Technical Note

2012:29

Initial review of chemical and erosional
processes within the buffer and backfill
– Geochemical processes

This report consists of a Technical Note in SSM's initial review phase of SKB's safety analysis SR-Site. The aim of the initial review of issues concerning geochemical processes in buffer and backfill in a final repository is to make a broad illustration and review of SR-Site together with its subordinate references, as well as to identify potential needs for complementary information or clarification which SKB should supplement to its license applications.

Figure 2.2.1_1. Experimental (symbols) and estimated (lines) surface-area normalized dissolution rates for a smectite (Huertas et al., 2005).

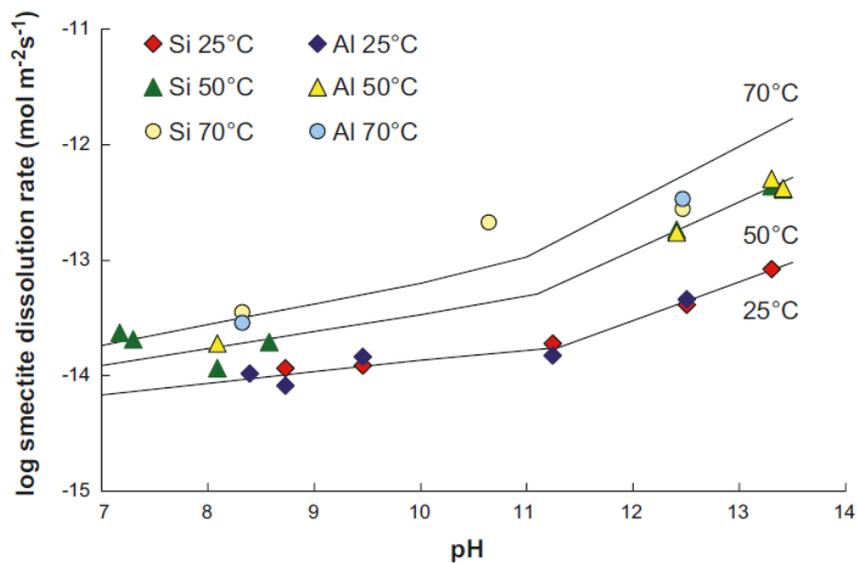
A similar line of reasoning is based on an experimental study of smectite dissolution kinetics between pH 7 and 14 at 25, 50 and 70°C (Huertas et al., 2005). The experimental results indicate that surface-area normalized rate constants for smectite dissolution under far-from-equilibrium conditions tend to increase with increasing pH (Figure 2.2.1_1). Huertas et al. (2005) speculate that the rate at which the rate constant increases with increasing pH changes abruptly at about pH 11, although this view seems to be based on a rather subjective fit of estimated rate constants with their experimental counterparts. Based on these results, SKB concludes that smectite will be stable in the repository environment for at least 1,000,000 years as long as the pH of buffer/backfill porewaters remains below pH 11 (SKB 2011, page 397).

The technical basis for this conclusion may not be adequately supported for several reasons. The dissolution rate can only reflect how quickly smectite might achieve equilibrium with an aqueous solution at a given pH and temperature, not whether smectite would be thermodynamically stable under such conditions. The conclusion is moreover based on the pH-dependence of the dissolution rate constant at various temperatures, whereas the actual dissolution rate will also depend on smectite reactive-surface area, and thus on the microstructure of compacted buffer and backfill materials. The nature of such microstructure is uncertain and a subject of much debate (e.g., Savage et al., 2011), which suggests that interpretations of smectite stability based solely on the pH-dependence of the dissolution rate constant may be overly simplistic. Also, because smectites are multi-constituent solids, equilibrium stability relations cannot be interpreted based on pH alone. Such relations have been interpreted in terms of the aqueous activities and activity ratios of all constituents affecting the stability of smectite and possible alteration phases, including H^+ (e.g., Garrels, 1984; Aagaard and Helgeson, 1983). SKB has apparently chosen not to follow this approach for reasons that should be clarified.

Given the safety relevance of the $pH < 11$ safety function indicator criterion and the questionable justification for selecting this criterion in SR-Site, SSM should further evaluate the reasoning behind this justification during the Main Review Phase of the PCS project (Appendix 3). Such an evaluation should include a detailed review of established alternative methods to those considered by SKB for interpreting smectite stabilities as a function of temperature, mineral chemistry and aqueous solution chemistry.

1. SSM should carry out an independent technical evaluation of the pH < 11 safety function indicator criterion adopted in SR-Site (Section 2.2.1). The evaluation should consider established alternative methods to those adopted by SKB for the interpretation of smectite stability as a function of temperature, mineral chemistry and aqueous solution chemistry.

Figure 2.4.2_1. Schematic representation of the microstructure of compacted bentonite (from Sena et al., 2010, after Wersin, 2003)

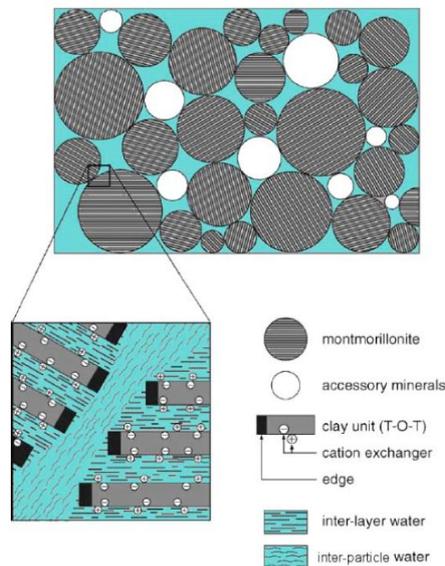
Multiple-porosity models are based on the assumption that the following types of porosity can exist in compacted bentonites (Figure 2.4.2_1):

The effects of Donnan processes and anion exclusion are considered to be negligible in the SR-Site model of buffer/backfill geochemical evolution (SKB 2011, Sections 10.3.10 and 10.4.8; Sena et al., 2010) and in this sense the model seems to represent a multiple-porosity type model in which external porosity is homogeneously distributed and equal to the total porosity. Justification for this assumption comes from the good agreement claimed by Sena et al. (2010) between observed results for the transport of Cl^- and SO_4^{2-} in the LOT-A2 test parcel with corresponding modelling results obtained using a reactive-transport simulator (TOUGHREACT) that does not account for Donnan equilibria or anion exclusion. Although this justification may be valid, it would seem prudent from a reviewer's perspective to further explore the evident uncertainty and continuing debate concerning the nature of porosity in compacted bentonite. In particular, the Main Review Phase should evaluate, possibly on the basis of discussions with SKB, the potential impacts of alternative models of buffer/backfill geochemical evolution in which the possible existence of significant interlayer porosity and associated Donnan and anion exclusion effects are taken into account.

Any review during the Main Review Phase should, if necessary, include a component involving the use of alternative conceptual models and more comprehensive numerical models that can be used to independently evaluate the effects of bentonite microstructure on Donnan equilibria, anion exclusion and the geochemical evolution of the buffer/backfill. An example of such alternative numerical models is CrunchFlow (or CrunchFlowMC), which can be used to simulate mineral-water reactions and solute transport in the electrical double layer adjacent to clay-mineral surfaces (Steefel, 2009; Steefel and Maher, 2009)

5. SSM should evaluate alternative conceptual models of buffer/backfill geochemical evolution that take into account the effects of bentonite microstructure on various types of porosity, and associated constraints imposed by Donnan equilibria and anion diffusivities (Section 2.4.2). The evaluation should, if necessary, include an independent modelling capability in order to evaluate the alternative models quantitatively using state-of-the-art reactive-transport simulation software.
